GENERAL MOTORS
DCS7460
URGENT - DISTRIBUTE IMMEDIATELY

Subject: N252529080 - Service Update
RESS High Voltage Header Plug Missing

N252529080 RESS High Voltage Header Plug Missing

Revision: 00

7080859

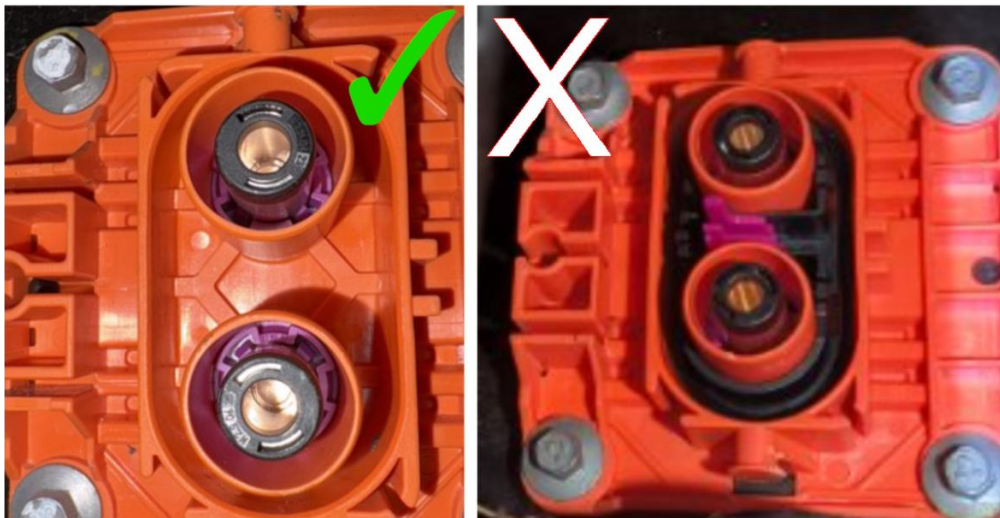
1. Perform SPS2 Hybrid/EV Battery Data Retrieval by following the directions in 25-NA-044.
2. Disable the high voltage system. Refer to *High Voltage Disabling* in SI.
3. Lift the vehicle. Refer to *Lifting and Jacking the Vehicle* in SI.
4. Remove the High Voltage Battery Tray Lower Rear Reinforcement if applicable. Refer to *High Voltage Battery Tray Lower Rear Reinforcement Replacement* in SI.

7103868

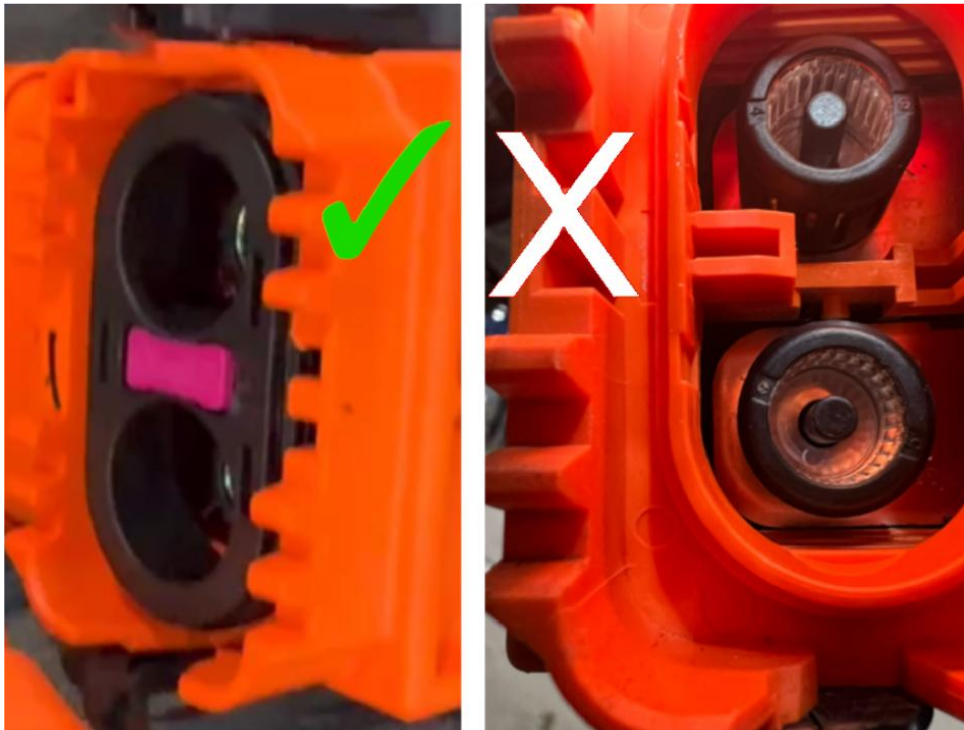
7. Inspect the X1 cable to see if it has a black insulator in it.
 - a. If the black insulator IS present, no further action is required.
 - b. If the black insulator IS NOT present, take photos of the cable end.

8. If directed to take a photo of the connector in either step 4 or 5, or the cable in step 7, contact TAC:
 - **U.S. Dealers:** Please contact GM Technical assistance (TAC) by initiating TAC CXC (CX Connect) Case in Global Connect, click on "New TAC Case" found on the Technical Assistance tab.
